**MONITORED NATURAL AND ENHANCED ATTENUATION OF THE
ALLUVIAL AQUIFER AND SUBPILE SOILS AT THE MONUMENT VALLEY,
ARIZONA, PROCESSING SITE: REVIEW OF FINAL STUDY REPORT**

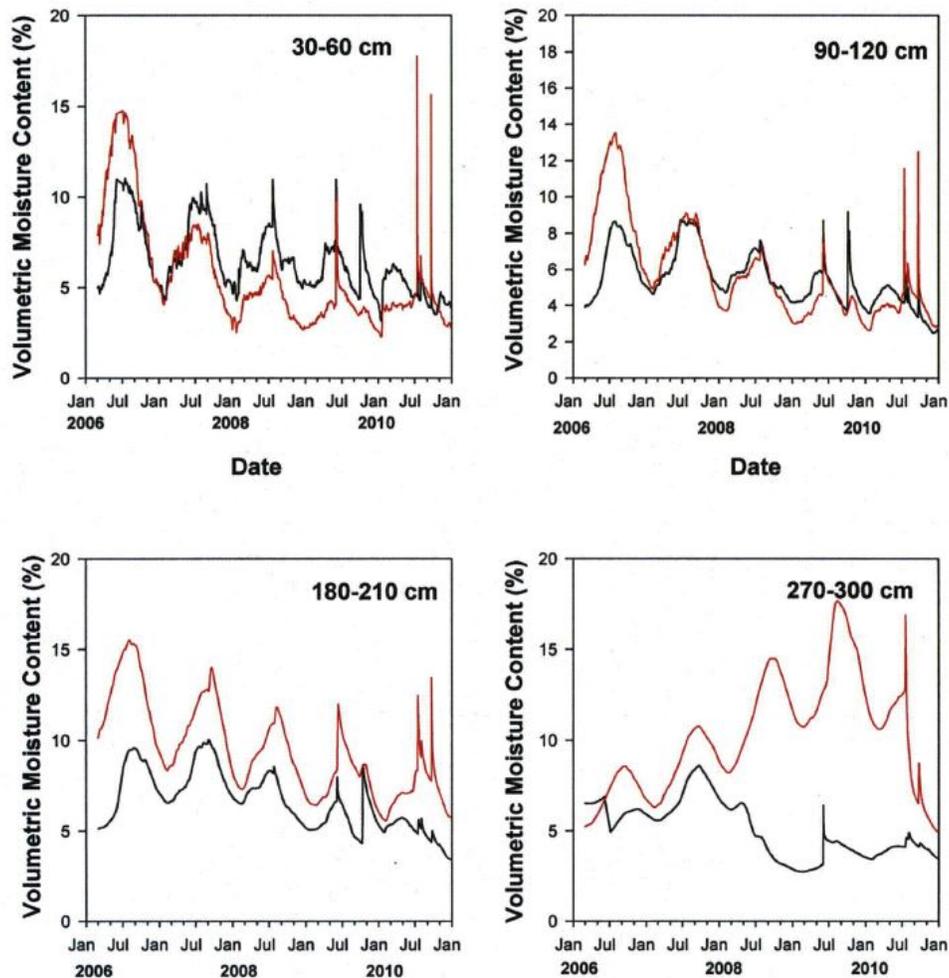
Questions remain regarding the conclusion by DOE of no downward water movement in the subpile soils including: (i) the water content deeper in the subpile soils for the Old Field appears to have an increasing trend, which may potentially result in downward water movement, especially if the trend continues; and (ii) only 4 water flux meters were used for the 3.3 ha [8.2 ac] of planted fields where enhanced phytoremediation was tested. For the former concern, Figure 3-1 shows an increasing trend of the soil water content at the 270–300 cm [106–118 inches (in)] depth. During the growing season of 2009 and 2010, it appears as if the volumetric water content exceeded the field capacity of $0.15 \text{ cm}^3/\text{cm}^3$ [15 percent] (Pilot Study Report, p. B–25). It is not clear why this increasing trend is only found in the Old Field. In a Groundwater Compliance Action Plan, DOE will need to give more detail on how irrigation will be managed to prevent an increase in water content deeper in the soil profile as shown in Figure 3-1. For the latter concern, data based on only 4 water flux meters for 3.3 ha [8.3 ac] may be insufficient to draw conclusions for all of the area. Only a single water flux meter was used on the Old Field. Because soils have heterogeneities in their structure, as do most natural porous media, downward water flux may be occurring at locations other than where the water flux meters are positioned.

In addition, DOE needs to provide further evidence that there is no downward water migration. Other than measurements of water content, there was only a single water flux meter in a 1.7-ha [4.2-ac] field (the Old Field). A single water flux meter is not sufficient to conclude that there is no downward water movement from subpile soils toward the alluvial aquifer. Further, DOE should explain why the water content at the 270–300 cm [106–118 in] depth appears to have an increasing trend, which may indicate downward water movement.

Figure 3-2. Initial Concentrations of Nitrate and Ammonium in the Old Field, 200, and the Amount of Nitrate and Ammonium Removed by 2010, As a Function of Soil Depth (Reproduced From the Pilot Study Report, Appendix B, Figure B-27).

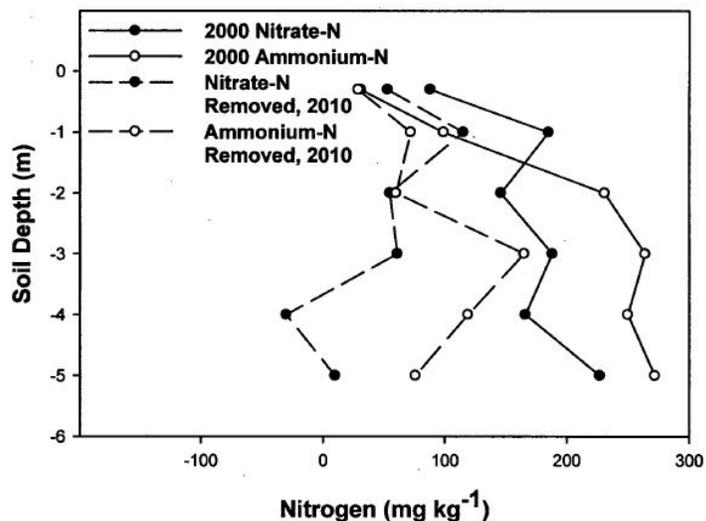
In addition, DOE needs to resolve the apparent contradiction between Tables 3-1 and 3-2 and Figure 3-2. In the tables, more nitrate appears to have been removed than ammonium. In the figure, more ammonium appears to have been reduced than nitrate. The increase in nitrate deeper in the subpile soil between 2004 and 2010 also needs to be clearly explained.

Figure 3-3. Distribution of Nitrate, Ammonium, and Sulfate as a Function of Soil Depth in Source Area Soil Samples From the Old Field in 2010 (Modified From the Pilot Study Report, Appendix B, Figure B–26)

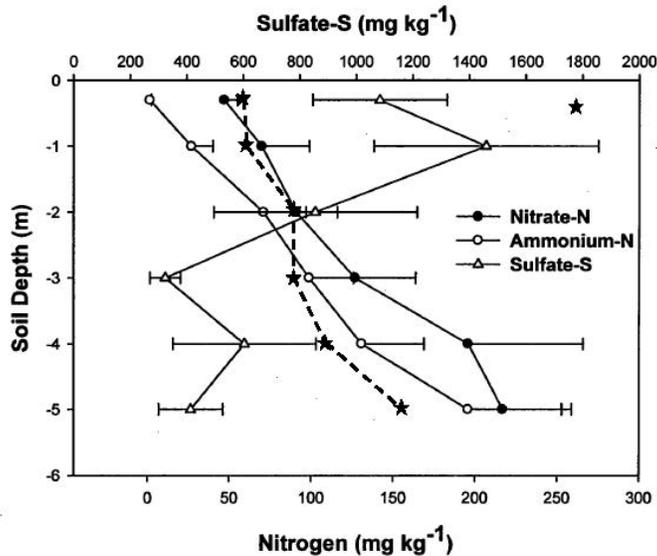
In Figure 3-3, DOE shows that the sulfate concentration in the subpile soils increased because the irrigation source contained sulfate. DOE did not address directly how this increase may affect the subpile soils and potential remediation activities over a long time period. The consequence of adding sulfate to the subpile soils, especially if long-term irrigation is proposed, will need to be investigated.

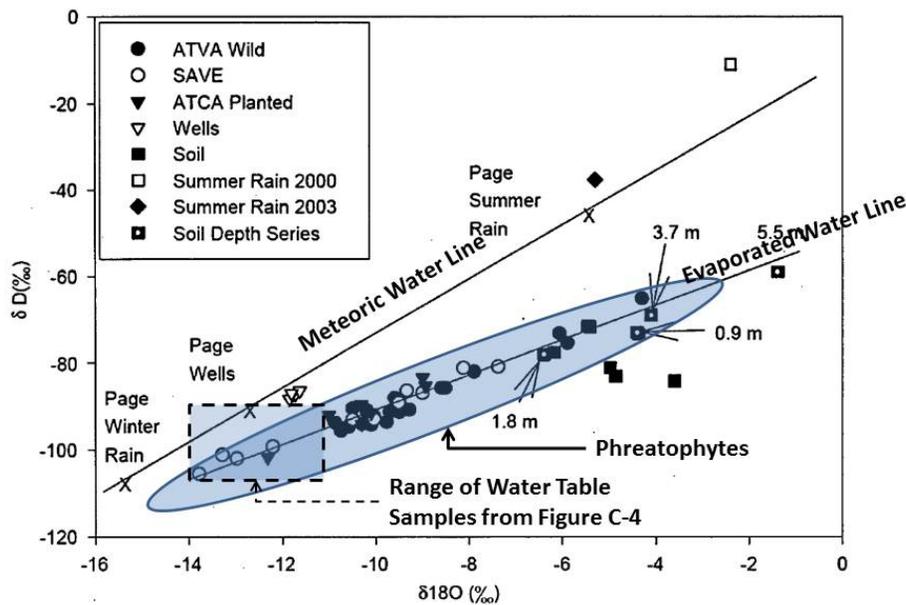
The results of the pilot studies do not provide a sound basis for determining the rate at which or extent to which either existing or enhanced phreatophyte communities would remove water from the alluvial aquifer or slow the movement of the nitrate and sulfate plume. Based on the following considerations, the phreatophytes may be primarily removing water from the vadose zone before it reaches the alluvial aquifer rather than directly extracting it from the aquifer. First, the hydrogen and oxygen isotope analyses do not unambiguously support the conclusion

that the phreatophytes are directly transpiring water from the shallow aquifer. Figure 3-5 shows the correlation of enrichment of Hydrogen-2 (δD) versus Oxygen-18 ($\delta^{18}O$) in groundwater, phreatophyte stem moisture, and the vadose zone water. The phreatophyte stem moisture isotopic ratios all fall on the evaporated water line, as do the soil water ratios, indicating the stem water could be derived either from the vadose zone or locally recharged water.

The Pilot Study Report does not provide clear estimates of how much water an enhanced population of phreatophytes would withdraw directly from the shallow alluvial aquifer versus the amount they would withdraw from the vadose zone. DOE should provide such an estimate and supporting calculations of the rate of groundwater movement to determine how an enhanced population of phreatophytes would affect the movement of the contaminant plume in both the shallow and deep portions of the aquifer.

Figure 3-6. Correlation Between Reported Annual Evapotranspiration (ET) and Annual Precipitation for Protected Phreatophytes (Plants Inside Fence) and Unprotected Phreatophytes (Outside Fence)

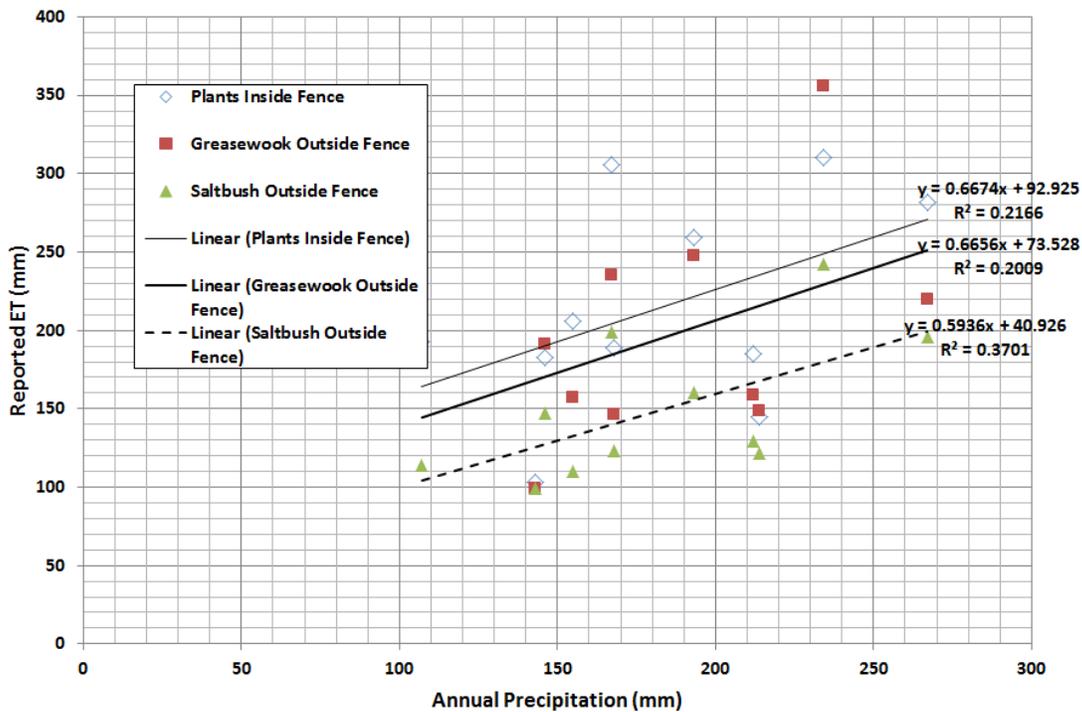
Second, the evapotranspiration rates measured for both protected and unprotected stands of saltbush and black greasewood increase with annual precipitation, as illustrated in Figure 3-6. This suggests that the phreatophytes may be primarily removing infiltrating water before it recharges that aquifer. If the phreatophytes are primarily removing water from the saturated zone the evapotranspiration rates would not vary with annual precipitation. (Note: according to DOE, the water flux meters measured no downward water flux.)
